**Safety Evaluation Report
Amendment 7 to License SUA-1601
Regarding License Condition 11.3(A) & (B)
Strata Energy, Inc. Ross ISR Project
Crook County, Wyoming**

This safety evaluation report (SER) documents the NRC staff's review of this amendment request.

Figure 1. PHAST Model Output for the a) Nichols Ranch and b) Ross simulations
Source: NRC (2017c)

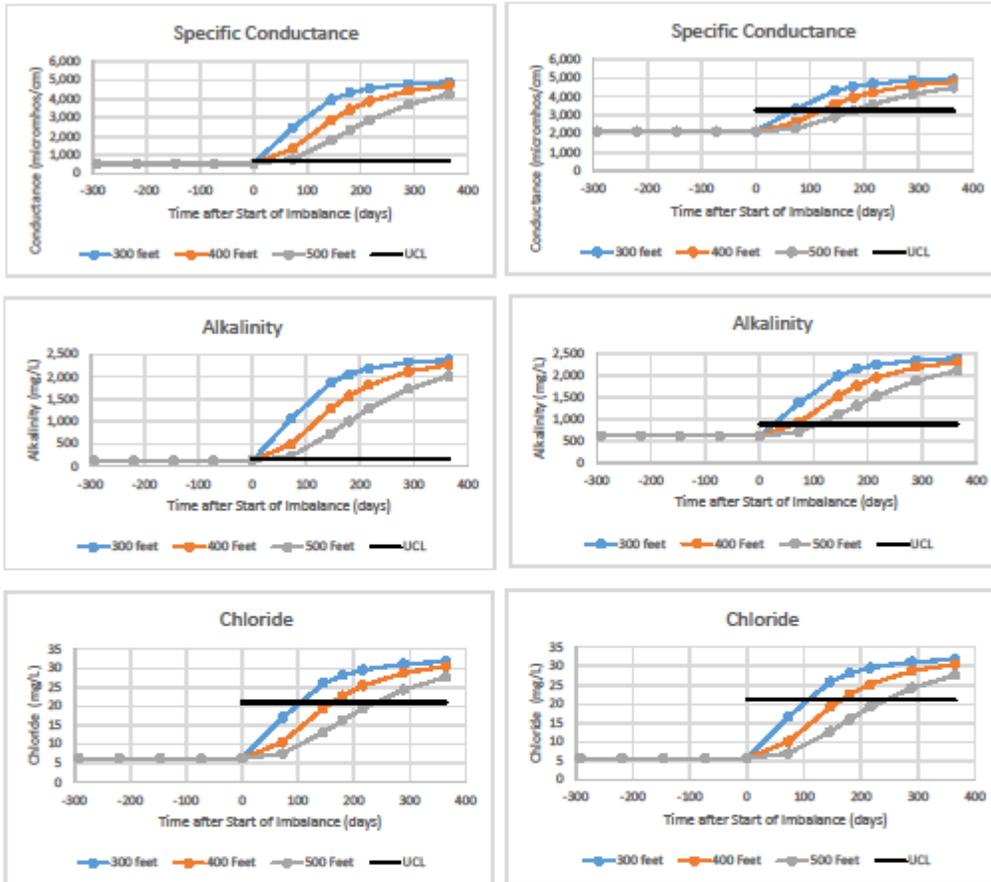
Results of the PHAST analysis are summarized in Table 3 and graphically shown on Figure 1. Based on the PHAST analysis, for all three constituents, the time to detect an excursion takes longer at the Ross facility at either 400 or 500 feet than it does at 500 feet at Nichols Ranch.

Based on the above, the NRC staff found that a distance greater than 400 feet to a perimeter well was not acceptable because of the increased time to detect an excursion. The 400-foot distance for the Ross facility had previously been approved by the NRC staff and is acceptable. A distance to the nearest production and perimeter well less than 400 feet is acceptable

because it would provide timelier detection of an excursion than at 400 feet. Therefore, the NRC staff found that Strata's request to amend License Condition 11.3(B) to allow variability in the distance to a monitoring well on the perimeter monitoring well ring was acceptable within the range of 300 to 400 feet.

Figure 2. Method for Determining Well-Specific Specific Conductance UCL for a Well at 440 feet

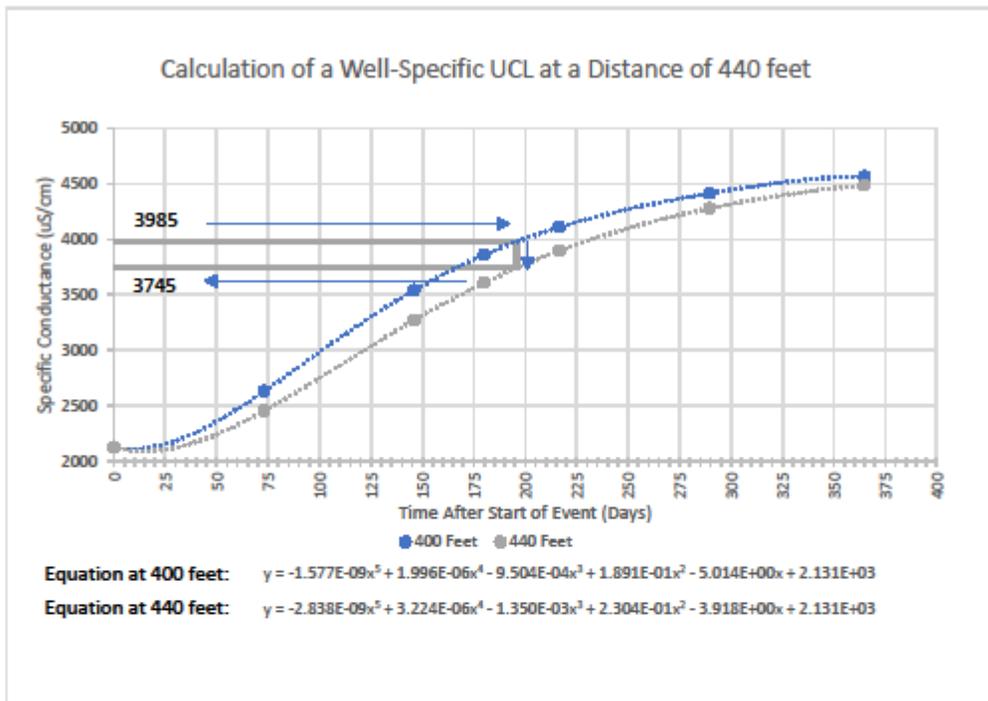
Third, NRC staff confirmed that Strata’s method to calculate a well-specific UCL (i.e., linear interpolation between data points) was appropriate. The NRC staff fitted the model-predicted specific conductance levels during the entire excursion event at both the 400- and 440-foot distance to a fifth-order polynomial equation for each respective distance. Then, using the polynomial equation for the 400-foot distance, the NRC staff determined the time to achieve the standard UCL. Next, using the time calculated above, the NRC staff estimated the specific conductance level at the 440-foot distance using its polynomial. The calculations are shown graphically on Figure 2. The NRC staff’s calculated well-specific specific conductance UCL at 440 feet is 3745 uS/cm, which is consistent with Strata’s calculated UCL of 3714 uS/cm.⁵

Therefore, with commitments documented in Strata’s page changes to the approved Ross license application, the NRC staff finds that Strata’s proposed methodology is acceptable because it would provide reasonable assurance of a timely detection of an excursion.
